File #: 22-835, **Version:** 1

CS22-0263 Discuss and consider an appeal of Sec. 144-5.22-3(c)(1) and Sec. 144-5.22-3(c)(2) Non-Residential and Multifamily Design Standards for vertical and horizontal building articulation requirements for a proposed food manufacturing facility with warehouse and office use in the "M-1" Light Industrial District, addressed at 1286 River Road.

Case #: CS22-0263

Horizontal Articulation - providing required offsets. Section 5.22-3(c)(1).

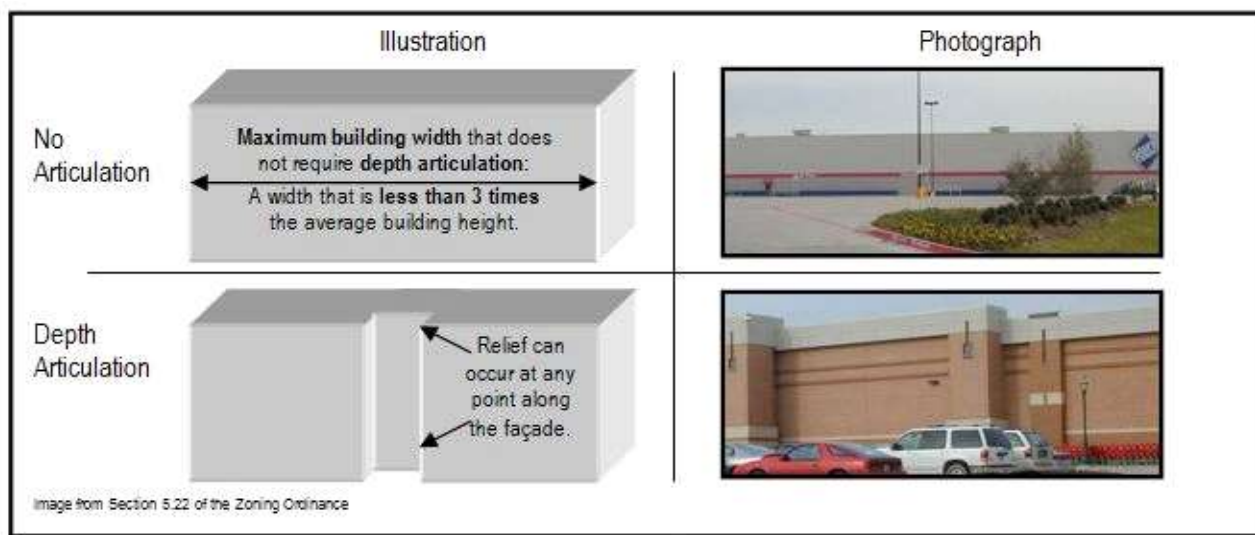
- The width of the west façade of the proposed building, facing River Road, is 150 feet with an average height of 34 feet. According to the design standards, no portion of the façade shall extend for more than three times the average height ($34' \times 3' = 102'$) without depth articulation (a change in the depth of the wall; in or out). To meet the design standards, there would need to be:
 - One horizontal offset (relief, in or out from the façade) at least 5.1 feet deep (15 percent of the average building height);
 - That that extends at least 15 feet in length;
 - Located or positioned on the façade so that no segment of the façade would extend for more than 102 feet without a 5.1-foot deep offset.
- The offset could be an inset or a protrusion as depicted in the following illustration.

- The west façade of the proposed building does not meet the horizontal standard since the building provides no horizontal articulation offset (see Attachment “Façade Elevation Drawing”).

Vertical Articulation - providing required changes in elevation. Section 5.22-3(c)(2).

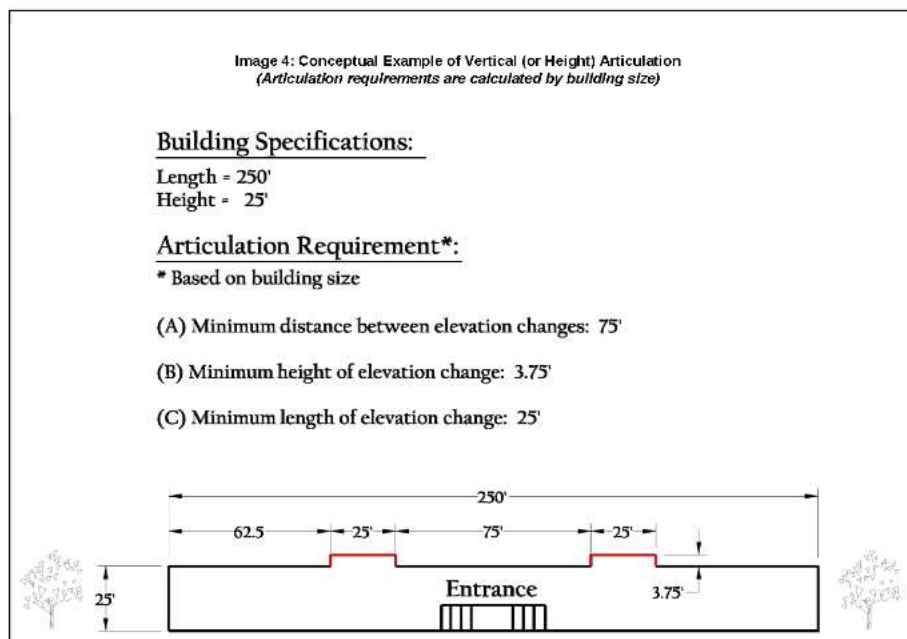
- According to the design standards no wall shall extend for more than three times its average height ($34' \times 3 = 102$ feet) without a change in elevation (the top of the wall or the roofline). To meet the design

- One change in elevation of the façade of at least 5.1 feet (15 percent of the average building height);
 - That that extends at least 15 feet in length;
 - So that no portion of the façade would extend for more than 102 feet without an elevation change.
- The elevation change would be calculated as depicted in the following illustration.

- The west façade of the proposed building does not meet the vertical standard since the building does not provide any elevation changes (see Attachment 4) and extends for a length of 150 feet.
